PR188 HYLANDS ROAD -DESIGN AND ACCESS STATEMENT

03.5.8 SECOND PRE - APPLICATION MEETING WITH WALTHAM FOREST COUNCIL

SECOND PRE-APPLICATION ADVICE

P2147: HYLANDS ROAD, WALTHAM FOREST
Figure SSD1
Stopping Sight Distances from Proposed new Site Access (North)

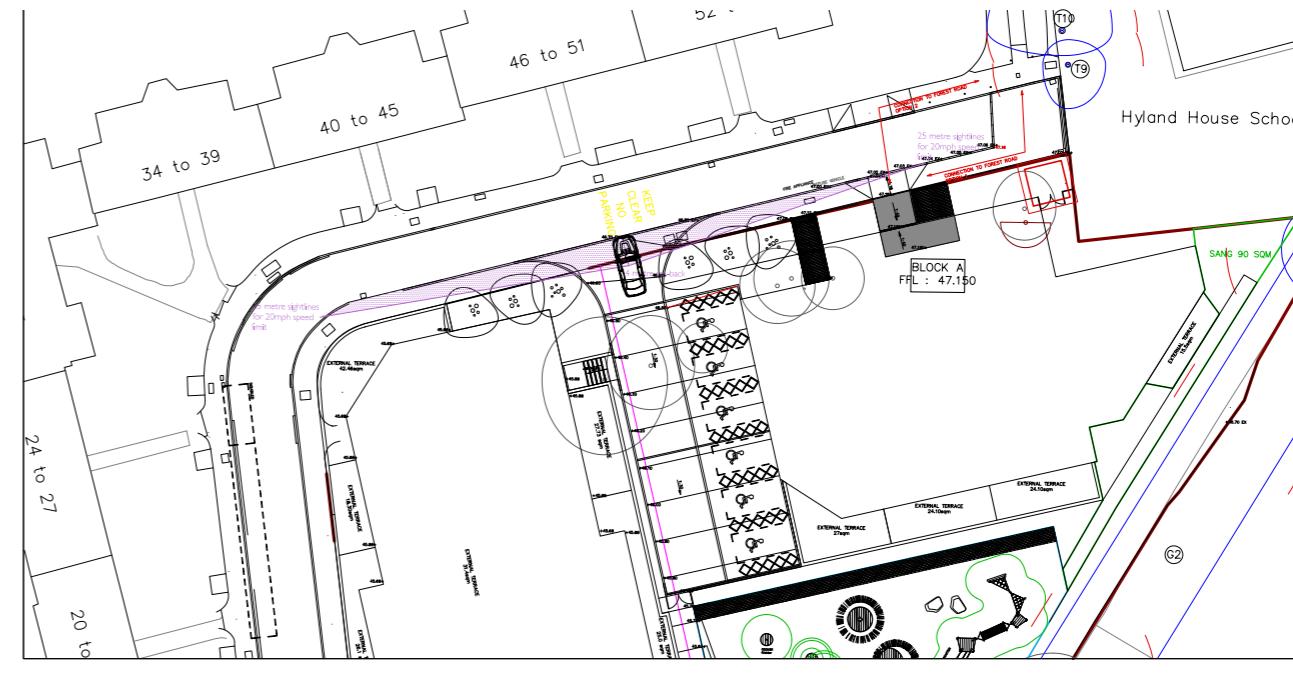
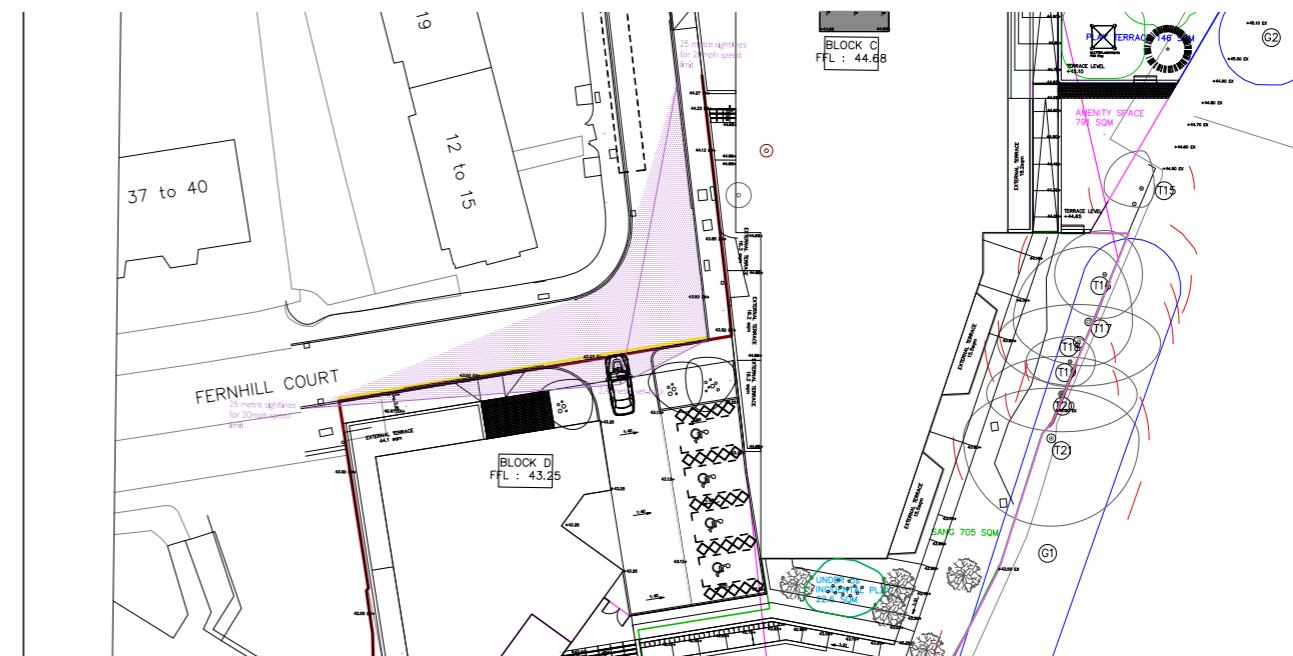
- Highways officer commented on proposed road layout and tracking diagrams presented, requested more tracking analysis to prove site layout work (in particular visibility splays for disabled drivers) See analysis spray diagrams to the right demonstrating high level of visibility for all drivers developed after the meeting for issue to the highways officer.
- Concern raised over where drop-off and delivery stopping areas would be. PMA carried out a traffic flow survey following the pre-app meeting and analysed that traffic flow in the area was extremely low at all times of day and night and that kerb side loading would have no material impact on highway capacity of road safety owing to the low baseline traffic flow.

Stopping sight distances tested in response to pre-app meeting comments

03.5.9 SECOND PRE-APPLICATION MEETING SCHEME [POST-SUBMISSION]

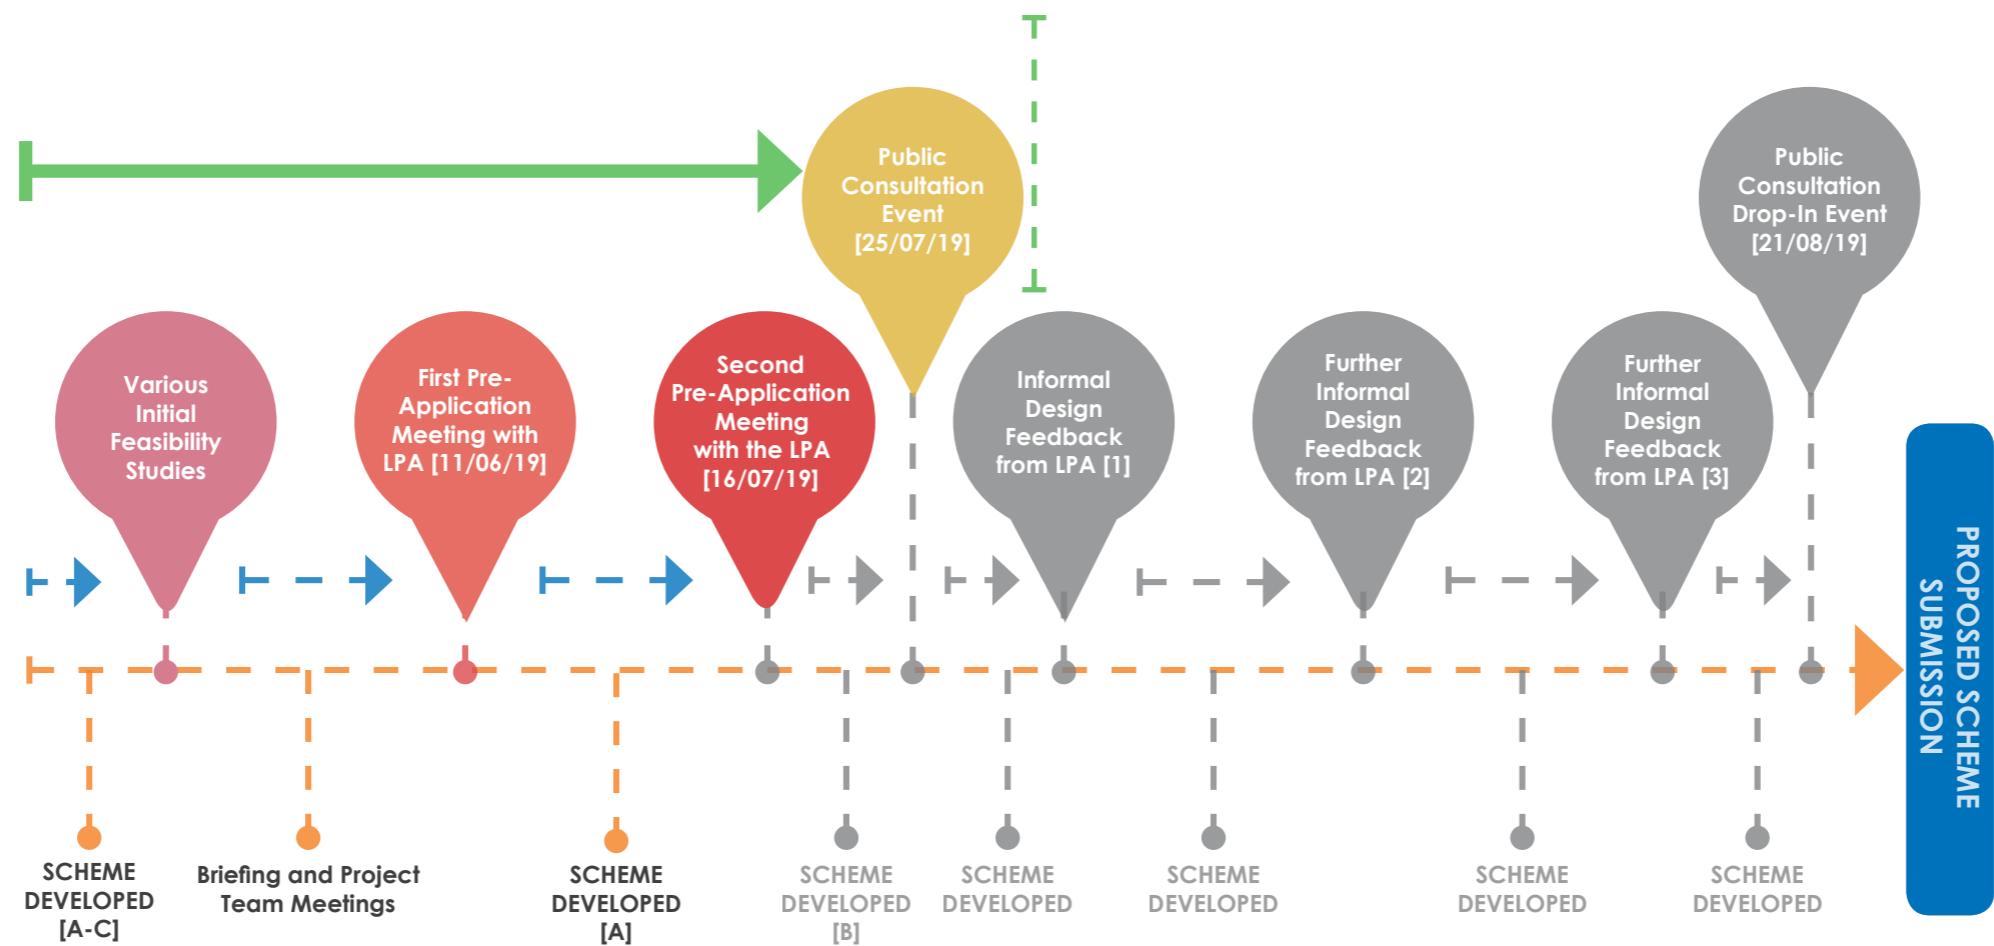
- Proposal needs to work harder to break down the massing, suggestion of developing this through 'stepping' of buildings needs to be explored
- Can a better scheme be achieved by lowering building heights where Hylands Road turns (site is the most compact here) and step up to the South to create a 'bookend' building

- Both in terms of sitting appropriately within the context and creating a development a well-designed and well defined development (which further aids wayfinding) the heights and massing should be more sensitively handled and varied

- Recommend the layout and massing are revised to show a more sensitive reading of the site.
- The most appropriate location for height would be the southern part of phase 2

DESIGN REVISED FOLLOWING PLANNER REQUEST TO ISSUE NEW SCHEME
ADDRESSING COMMENTS

03.7.1 REVISED DESIGN FOLLOWING INFORMAL LPA FEEDBACK

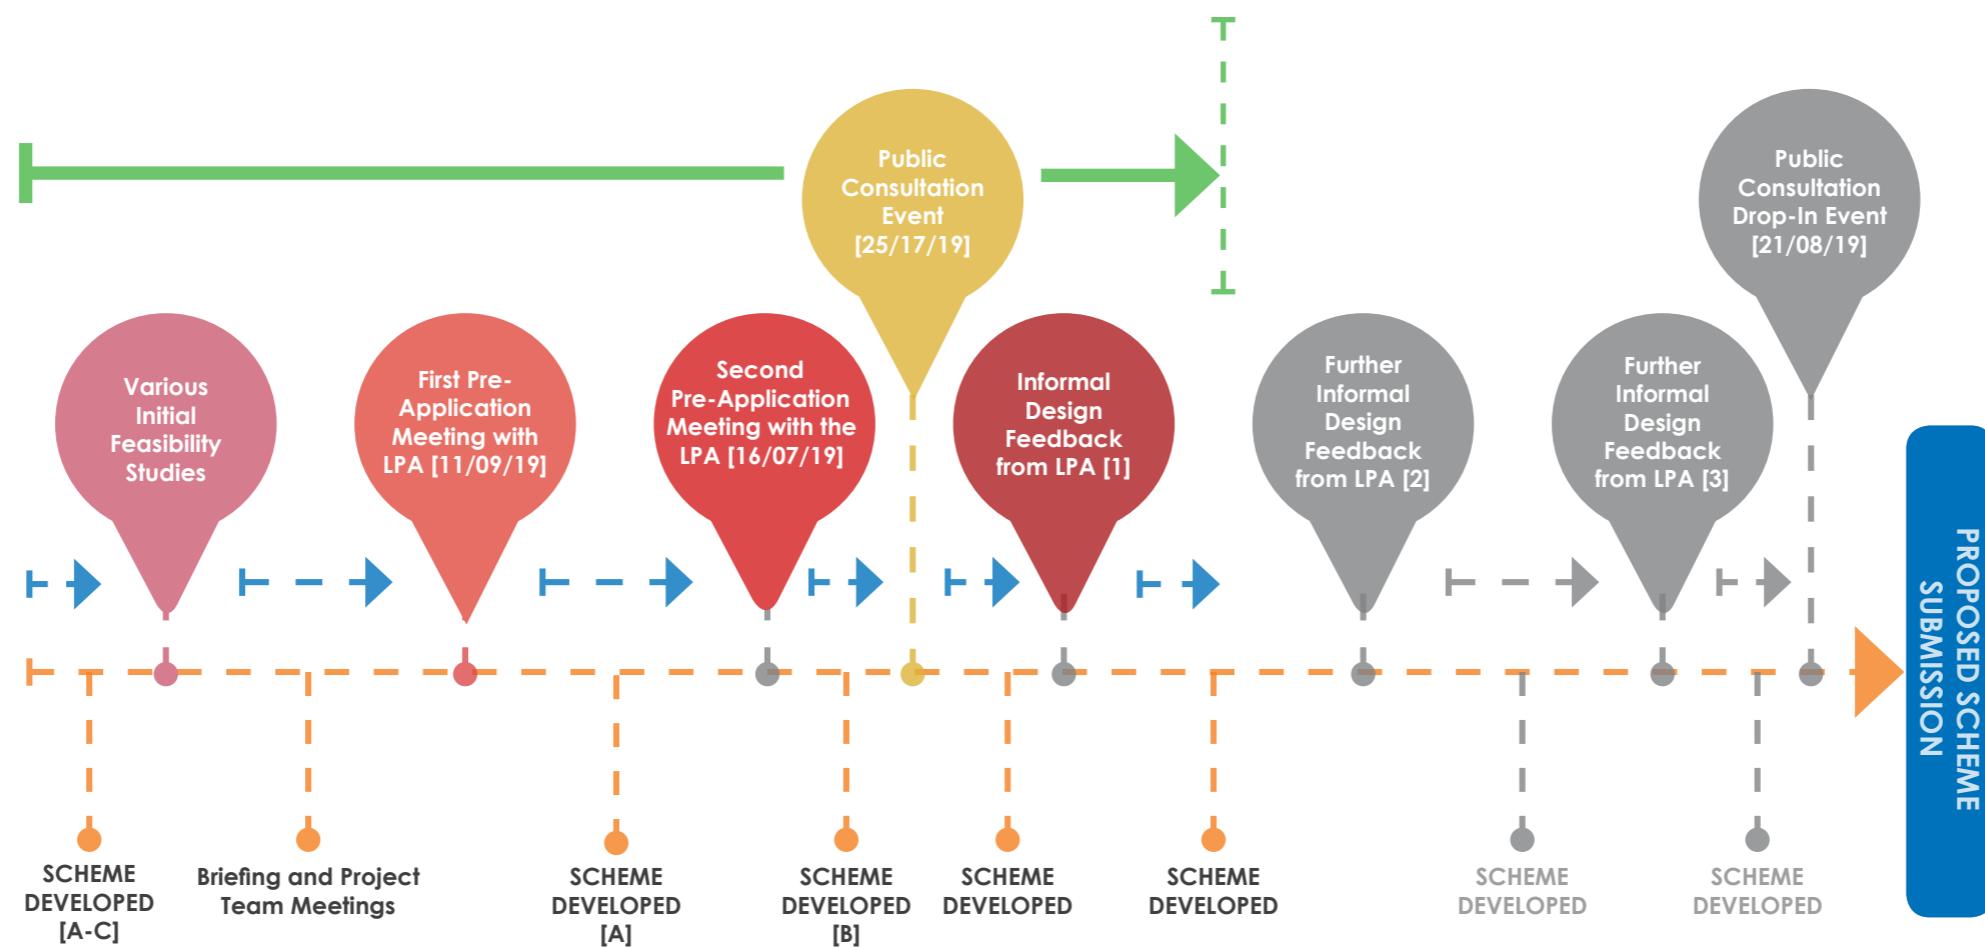
Informal feedback was received between senior members of the planning department and the client project team. Feedback was that there was a concern about the massing of the blocks anchored around the street frontage of Hylands Road and that they wanted to see another version of the scheme that opened up the corner of Hylands Road.

In this iteration of design development we explored two parallel blocks that opened up the site to create a 'linear park' to connect the surrounding context with Epping Forest.

This scheme also looked at the impact of achieving all 120 units on just phase one and two, leaving three as communal amenity or playspace.
